**PLANNING APPROVAL &
SUBDIVISION STAFF REPORT****Date: April 4, 2013**

NAME Cottage Hill – Azalea Subdivision

CONTEMPLATED USE Planning Approval to allow a seafood store in a B-2, Neighborhood Business District, and Subdivision approval to create one legal lot.

SITE PLAN

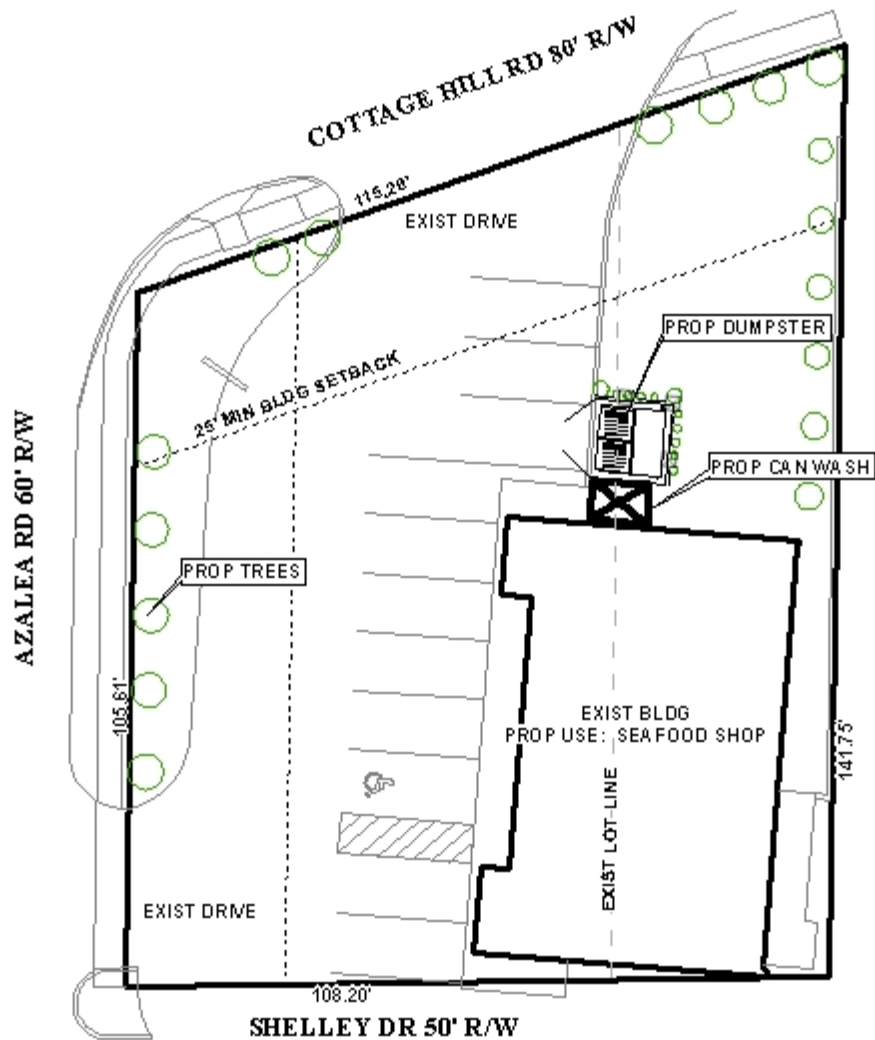
The existing building has a "loading dock" on the rear, which apparently is accessed via a pedestrian ramp leading to Shelley Drive. The proposed site plan does not depict the ramp. Also, it appears that a portion of the sidewalk servicing the building extends into the right-of-way of Shelley Drive. The existing building itself abuts the Shelley Drive (with no setback at one corner), and with between a 6 to 9 foot setback from the East property line.

The 25-foot minimum building setback line should be revised on the site plan and plat to reflect any required dedication.

Since the site has frontage onto two proposed major streets and a minor street, access management is a concern. The site currently has large curb-cuts to all abutting streets. Since Shelley Drive is a minor residential street, the curb-cut should be closed and landscaped with sod. Traffic Engineering has requested that the curb-cut to Cottage Hill Road be located as far to the East from the intersection as possible, be reduced in width to 24-feet, and be designed to only allow right in, right out traffic. The site plan also depicts a reduction in width for the existing curb-cut to Azalea Road, with its narrowing down to approximately 24-feet from a nearly continuous curb-cut at this time: a right in, right out restriction may also be appropriate for the site's frontage along Azalea Road. The size, design and location of any curb-cut modifications must be approved by Traffic Engineering and comply with AASHTO standards.

The existing building is approximately 2,800 square feet, thus a minimum of 10 parking spaces will be required. The site plan depicts 10 spaces. It should be pointed out that the dedication which may be required along Azalea Road will result in an on-site maneuvering area that may not be able to accommodate 90-degree parking due to insufficient width. The applicant should revise the site plan to accommodate any required right-of-way dedication. Any parking areas abutting Shelley Drive should be screened with a 3-foot high evergreen hedge or fence per the requirements of the Zoning Ordinance

New trees and landscape areas are depicted on the site plan. As dedication may be required along both major streets, the site plan should be revised to reflect right-of-way dedication, and all calculations regarding the minimum amount of trees and landscape area should be revised.

- 1) Revision of the site plan to reflect dedication of right-of-way along Cottage Hill Road and Azalea Road, to provide 50-feet from centerline;
- 2) Revision of the site plan to reflect dedication of a corner radius compliant with the requirements of Engineering, Traffic Engineering and Section V.D.6. of the Subdivision Regulations;

- 3) Revision of the site plan to reflect closure and landscaping of the curb-cut to Shelley Drive, and alteration to both the Azalea Road curb-cut (right in, right out only), and the Cottage Hill Road curb-cut (narrow to 24 feet, move as far East as possible, and limit to right in, right out);

- 4) Revision of the site plan to depict adjustments to parking layout and circulation because of dedication and curb-cut closures and width reductions;

- 5) Revision of the site plan regarding tree and landscape compliance, to reflect right-of-way dedication and other site modifications;
- 6) Revision of the site plan to reflect a 3-foot high vegetative buffer or fence where the parking abuts Shelley Drive;

- 8) Revision of the site plan to depict the 25-foot minimum building setback line.

DETAIL SITE PLAN - VERSION A

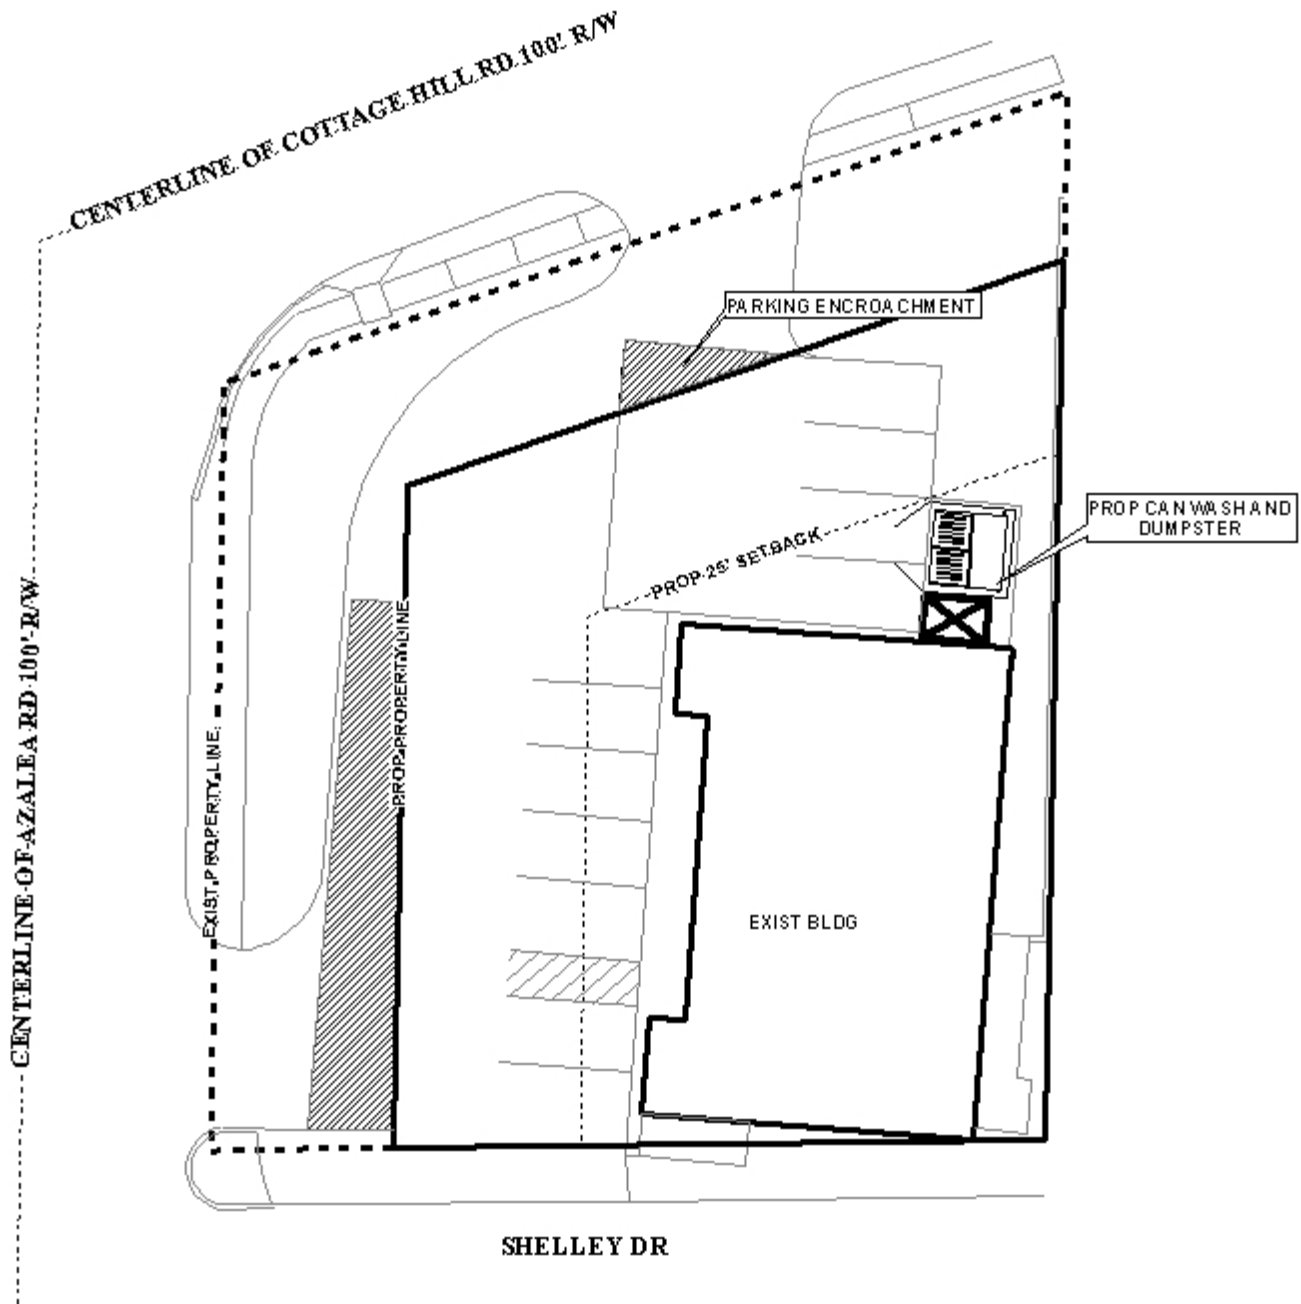
The applicant submitted a revised narrative and two site plans regarding the site. Each of the site plans depict the requested dedication along both Azalea Road and Cottage Hill Road, and how the dedication impacts the parking layout and circulation of the site. Version "A" shows the originally proposed layout with 10 perpendicular parking spaces, and shows how the required maneuvering area will extend substantially into the dedicated right-of-way (but still remain approximately 14 feet from the edge of pavement along Azalea Road). Version "B" shows 8 angled parking spaces, and while there is less impact to the dedicated right-of-way for

As stated in the revised Traffic Engineering comments, the curb-cuts to both Azalea Road and Cottage Hill Road should be additionally modified to be right-in, right-out only. The site plan should be revised to show and label the modification. Consultation with Traffic Engineering may be required to determine an acceptable design.

DETAIL SITE PLAN - VERSION B

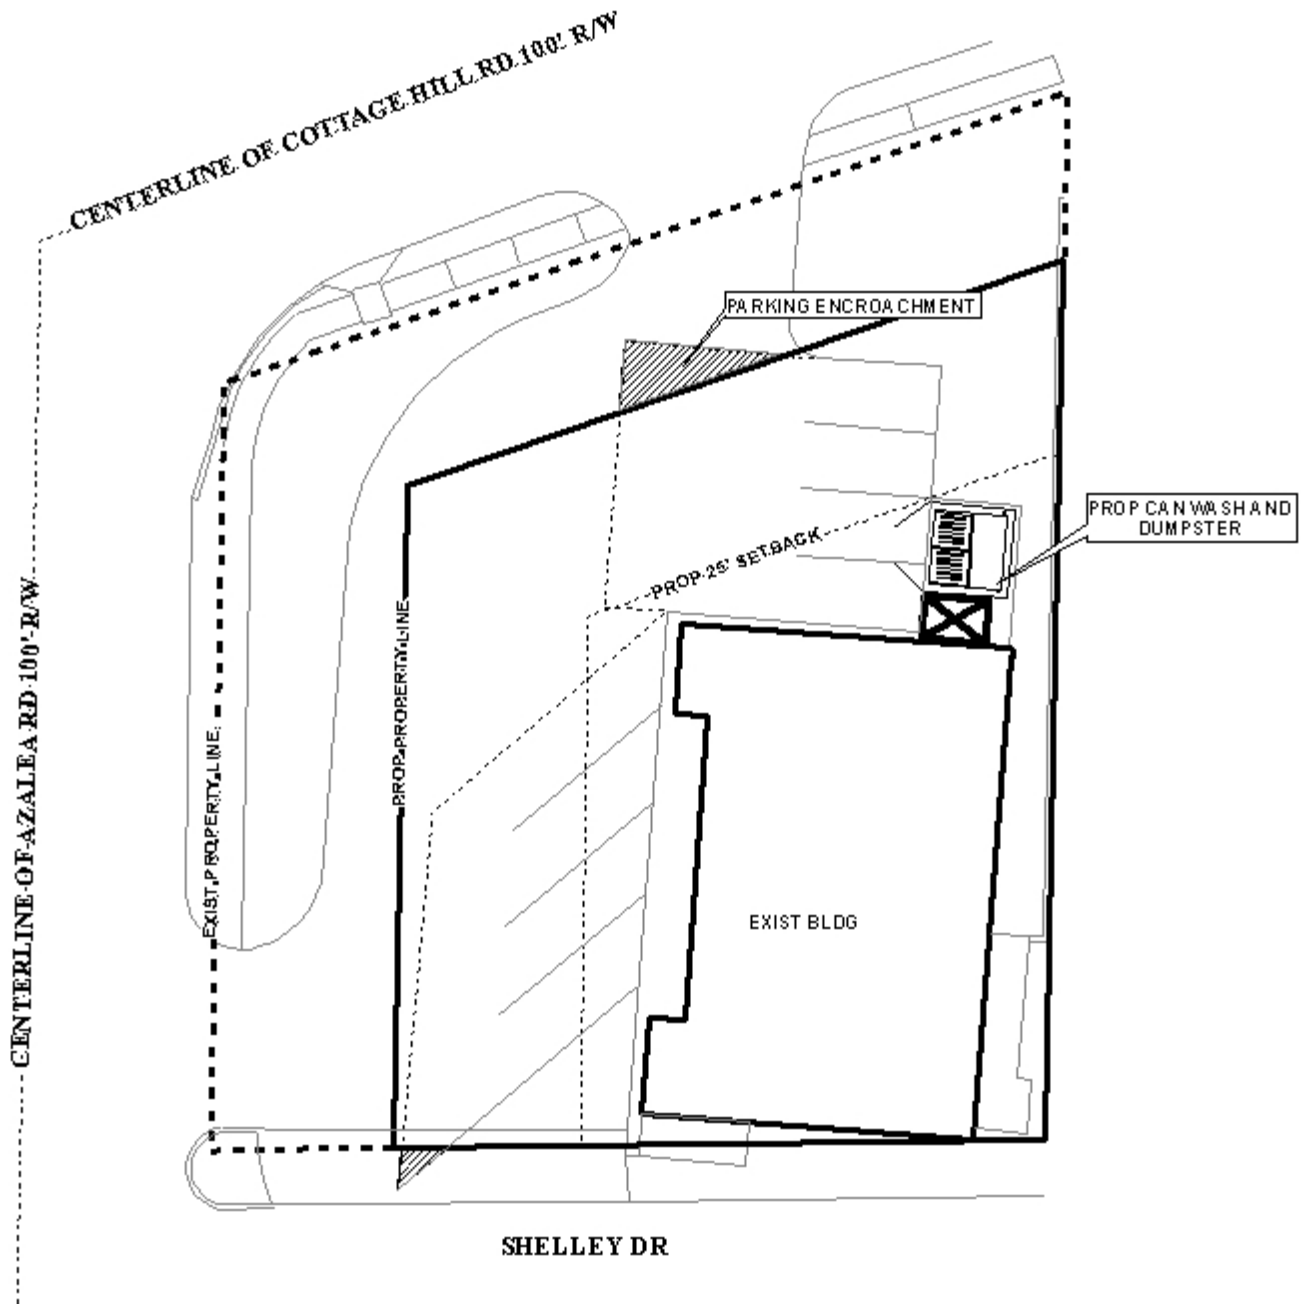
vehicle maneuvering, the lesser number of parking spaces results in the site not complying with the parking ratio requirements of the Zoning Ordinance.
